PCN No#: 111521-1

PCN Title: Additional Qualified (A/T) Assembly/Test Equipments

PRODUCT CHANGE NOTICE

Table A - Lead frame comparison and package outline comparison		
	Before Change	After Change
Lead frame		
Package outline

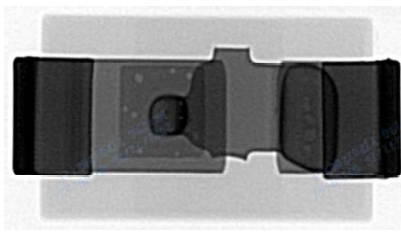
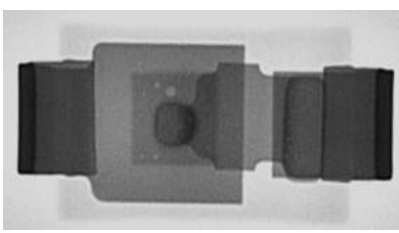
Notification Date	Implementation Date	Change Type	Classification	PCN No
Nov 15, 2021	Feb 15, 2022	Additional Qualified A/T	Major	111521-1
TITLE				
Additional Qualified (A/T) Assembly/Test Equipments				
DESCRIPTION OF CHANGE				
This PCN is being issued to notify customers that in order to assure continuity of supply, MCC has qualified additional (A/T) Assembly/Test Equipments. Full electrical characterization and high reliability testing has been completed to ensure there is no change to device functionality or electrical specifications in the datasheet.				
IMPACT				
No change in datasheet electrical parameters and product performance. Table A: Lead frame comparison and package outline comparison				
PRODUCTS AFFECTED				
Table B				
WEB LINKS				
Terms And Conditions:	https://www.mccsemi.com/Home/TermsAndConditions			
For More Information Contact:	https://www.mccsemi.com/Contact/Index			
Products:	https://www.mccsemi.com/ProductCategories
